# MONTGOMERY COUNTY HISTORIC PRESERVATION COMMISSION STAFF REPORT

Address: 8 Pine Avenue, Takoma Park Meeting Date: 5/27/2020

Case Number: 37/03-20W Staff: Dan Bruechert

**PROPOSAL:** Partial demolition, building addition

### Trex Transcend® Railing

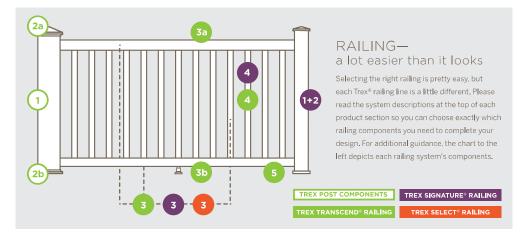
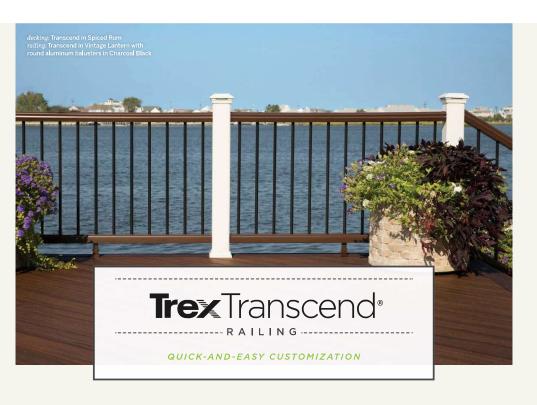
1. The proposed exterior railings need to be constructed out of wood with final approval authority delegated to Staff. Staff will verify this condition has been satisfied during the final review of the permit drawings.

Staff finds the proposed materials are generally consistent with the historic construction. The wood siding, asphalt shingle roof, windows and doors are all compatible materials with the historic house. The one exception is the proposed Trex railing. Substitute materials are frequently determined to be visually compatible with new construction and additions within the Takoma Park Historic District, even though they rarely develop the patina traditional materials do. These substitute materials, however, frequently lack the physical characteristics to be considered compatible when they are frequently touched and manipulated. So, most replacement materials for decking or railings or gates are not considered compatible under Chapter 24A or the *Design Guidelines*. Staff recommends including a condition for approval that the proposed exterior stair railing on the south and west elevations be constructed using wood, not the proposed Trex. Staff will be able to verify that this condition has been satisfied when the applicant submits construction plans for permit approval.

Staff recommends that the Commission approve the HAWP application with the condition that the exterior stair railings be constructed out of wood; under the Criteria for Issuance in Chapter 24A-8(b)(1), (2), (3), and (d) having found that the proposal, is consistent with and compatible in character with the purposes of Chapter 24A; the *Takoma Park Historic District Design Guidelines*;
